DOCUMENT 00 90 30
ADDENDUM No. 3

- A. The Construction Contract is known as:
SA009 – CIP – 12TH ST/CENTURY DR – PHASE 1
- B. Date of this Addendum: 2/13/2026

PP4

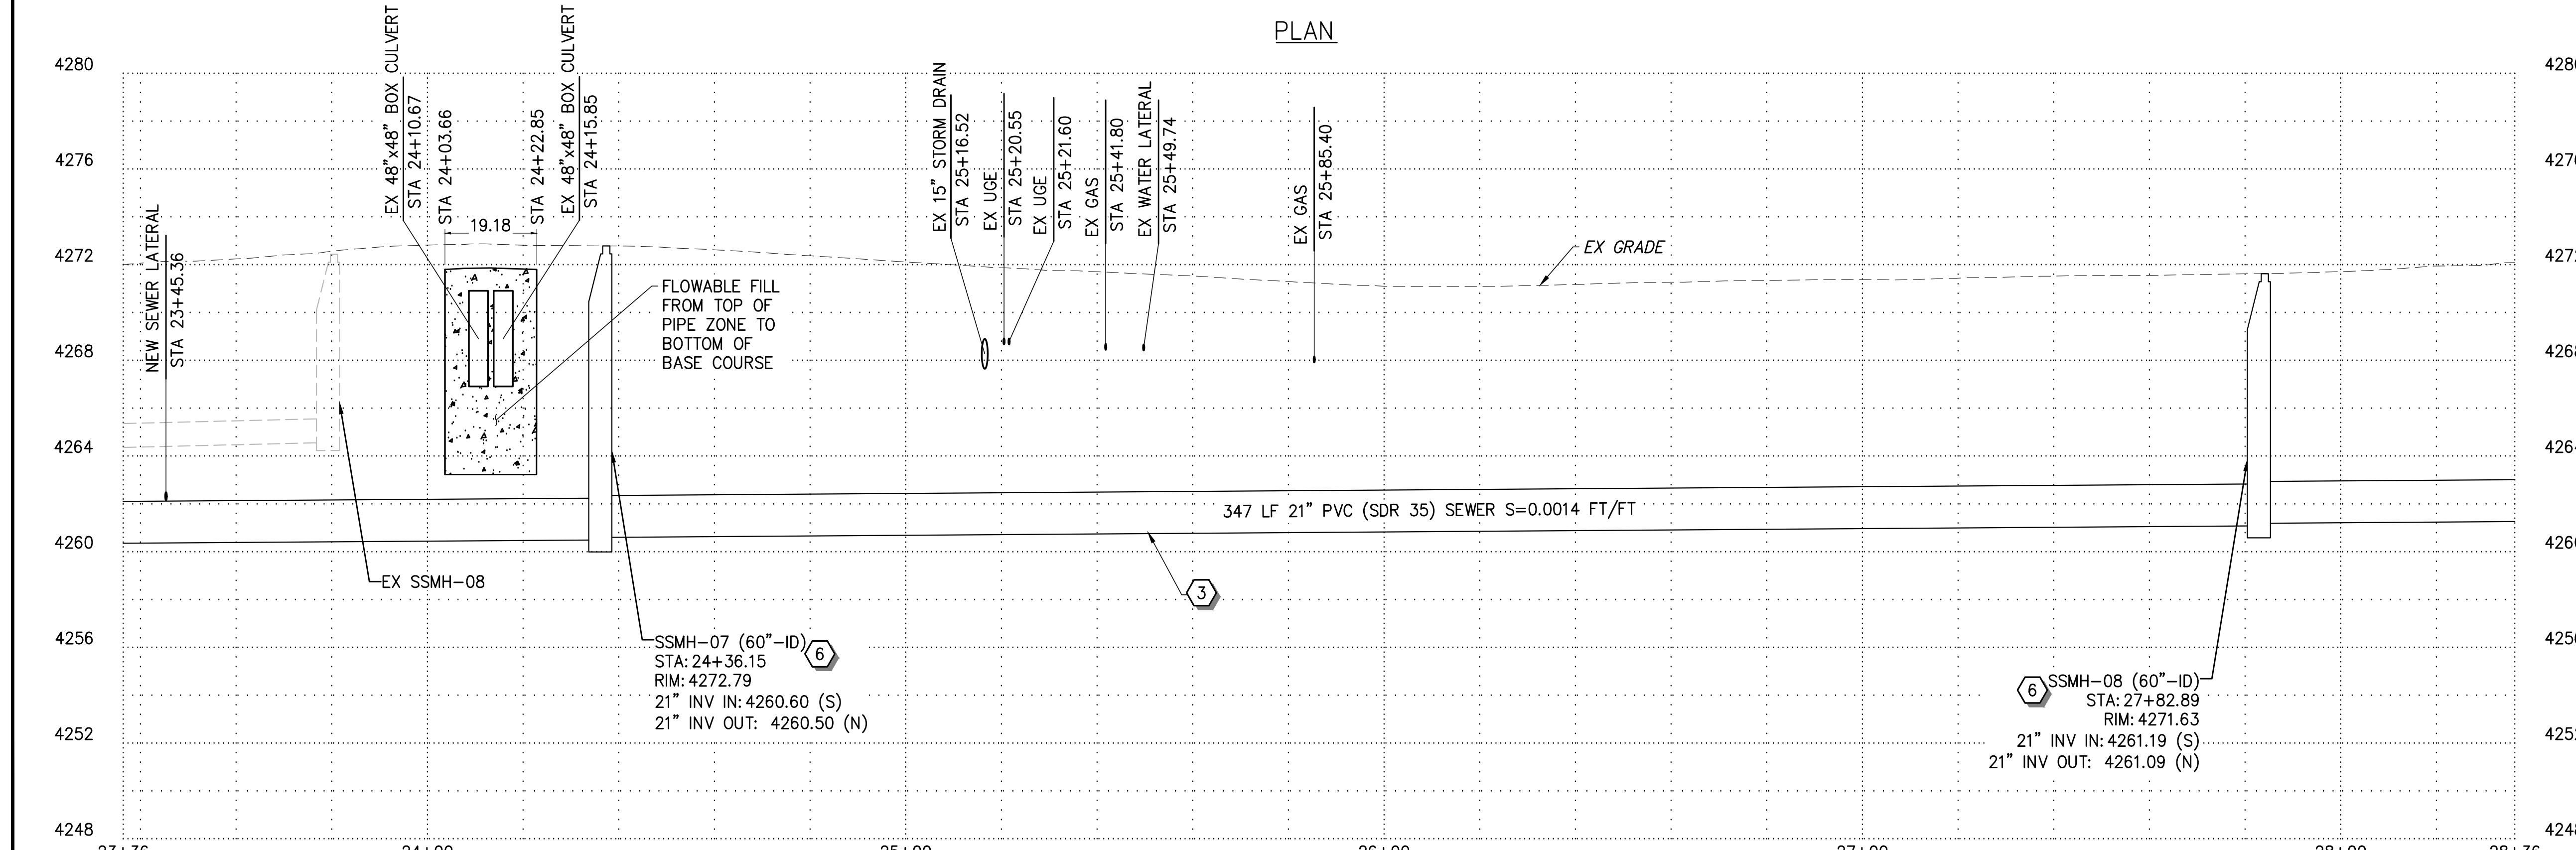
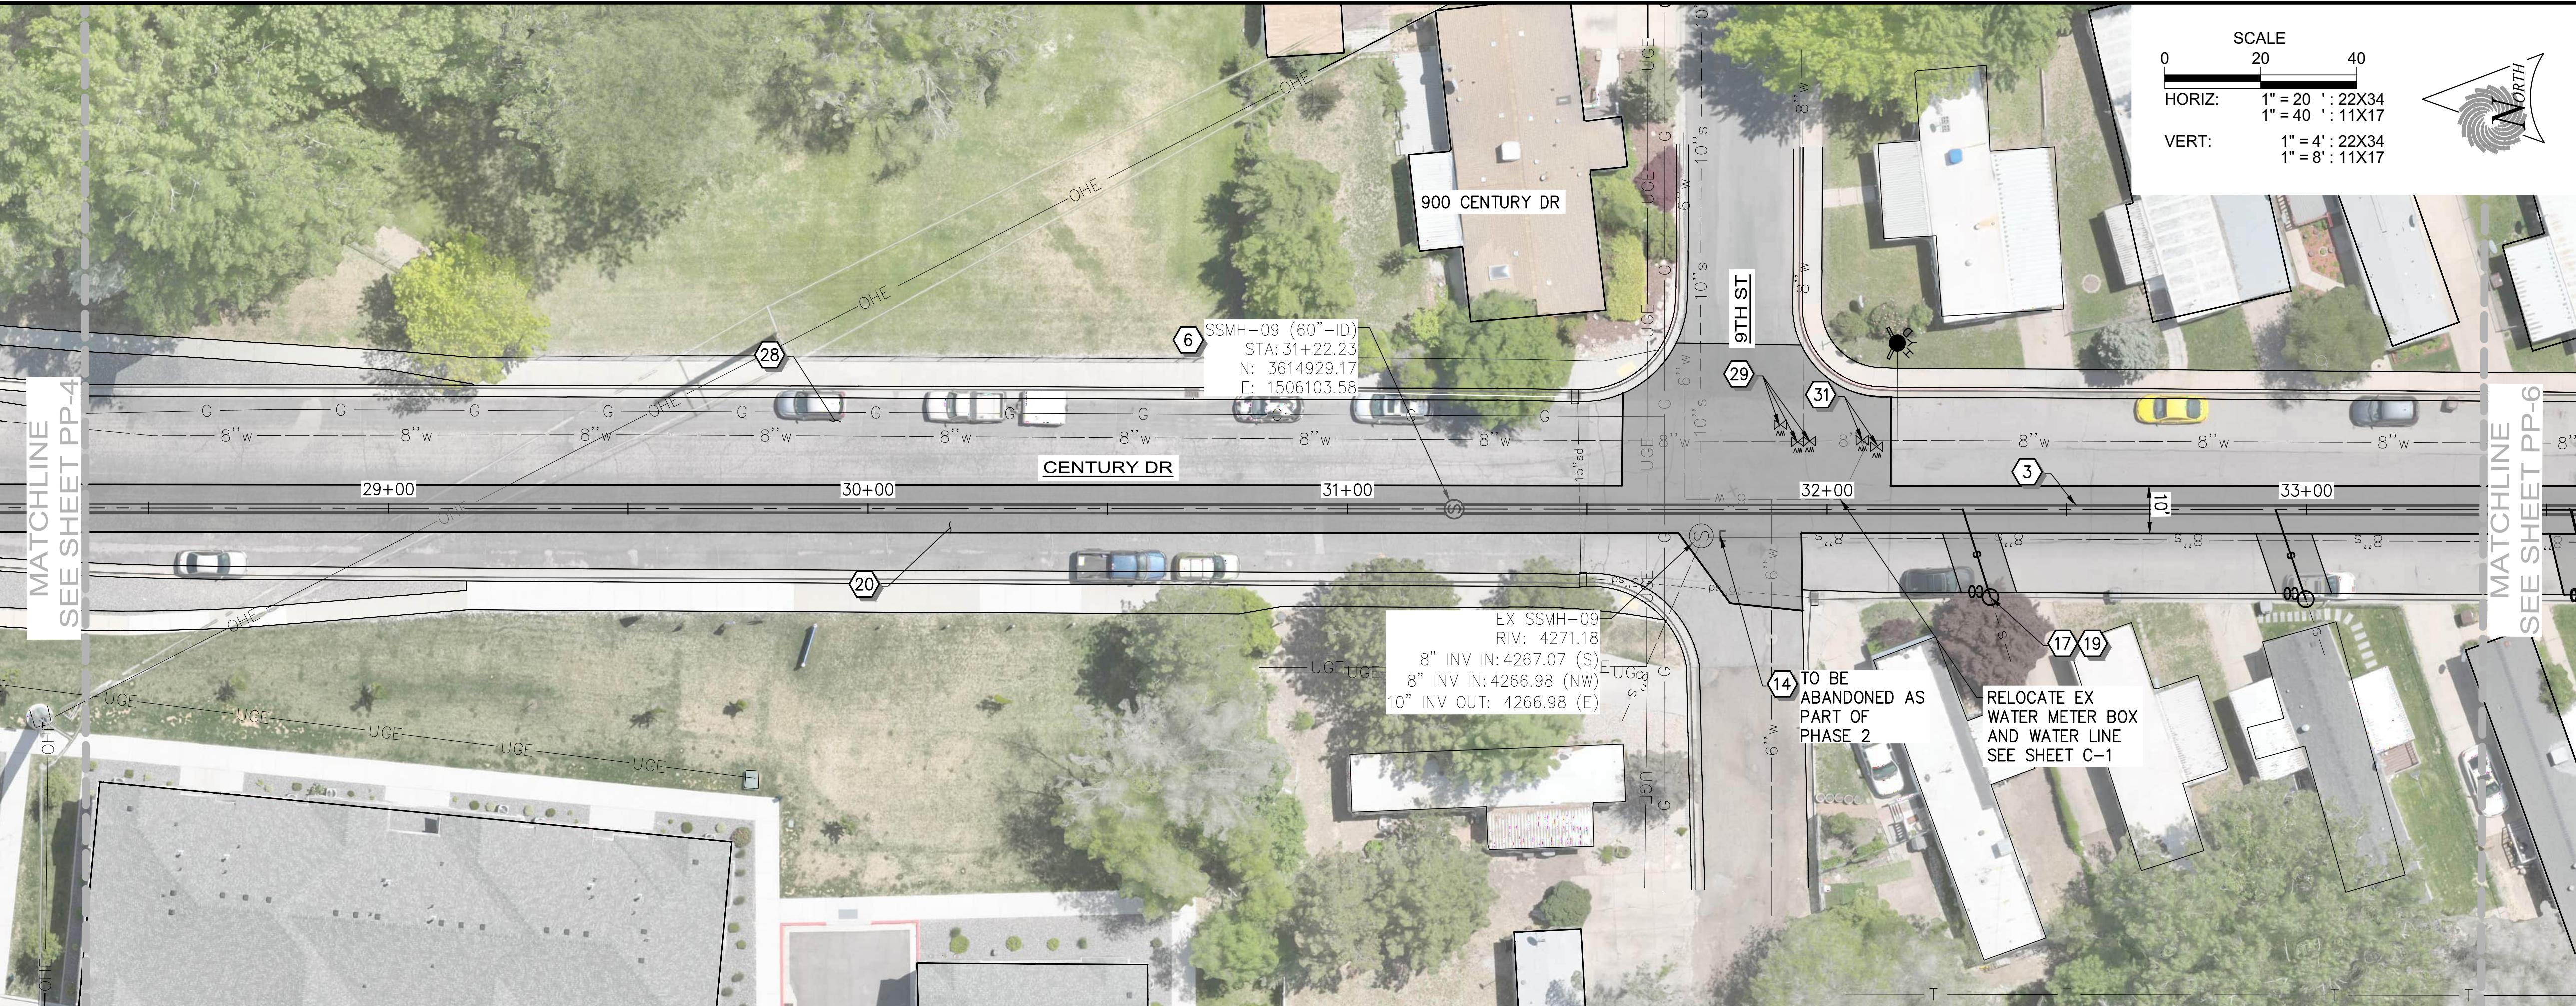
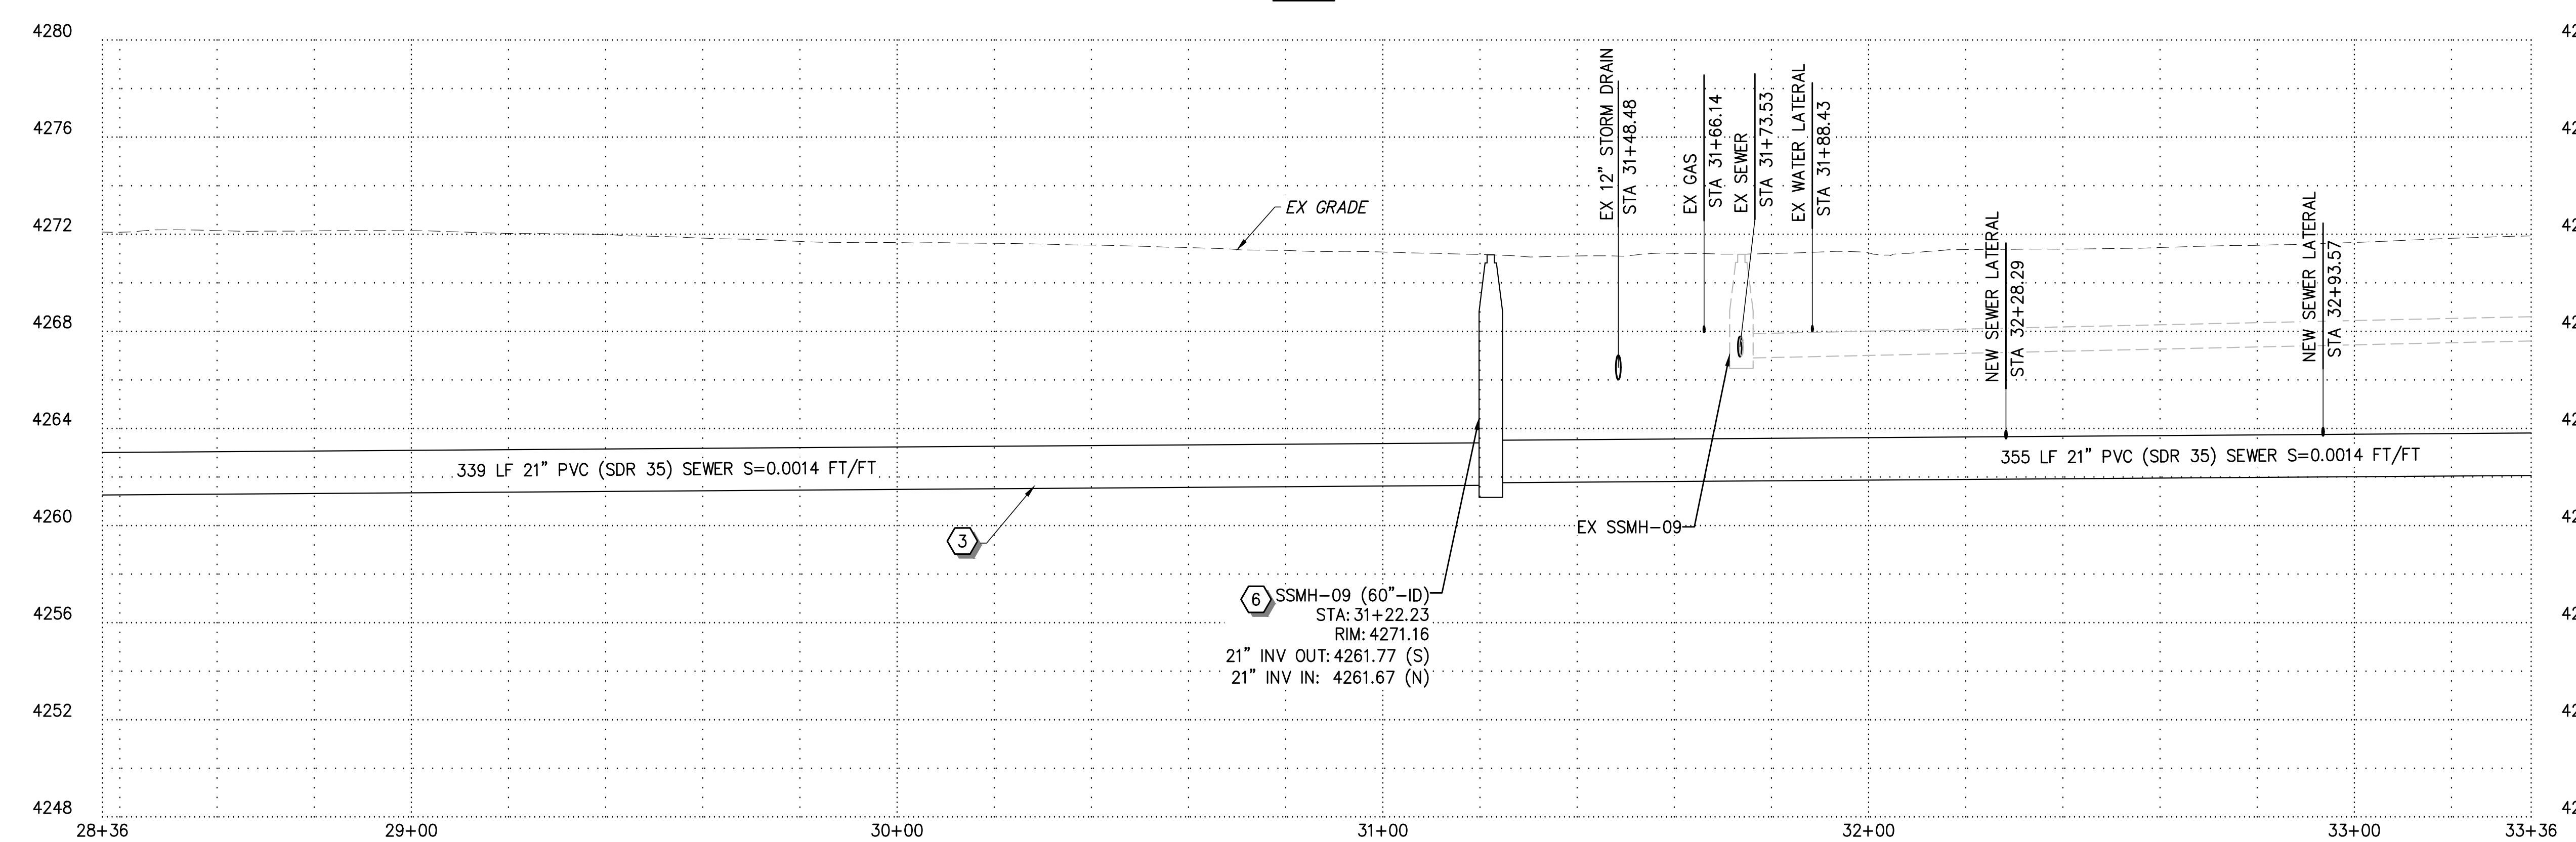
- A. Sheet PP-1 to PP-7 and C-1. Changed Construction Keynote 28 from "1" Mill and Overlay" to "2" Mill and Overlay"

- 22 RAISE AND COLLAR SURVEY MONUMENT
- 23 R&R CURB & GUTTER
- 24 R&R SIDE WALK
- 25 R&R FENCE
- 26 R&R UDOT PANELS
- 27 R&R UDOT CURB AND GUTTER
- 28 2" MILL AND OVERLAY
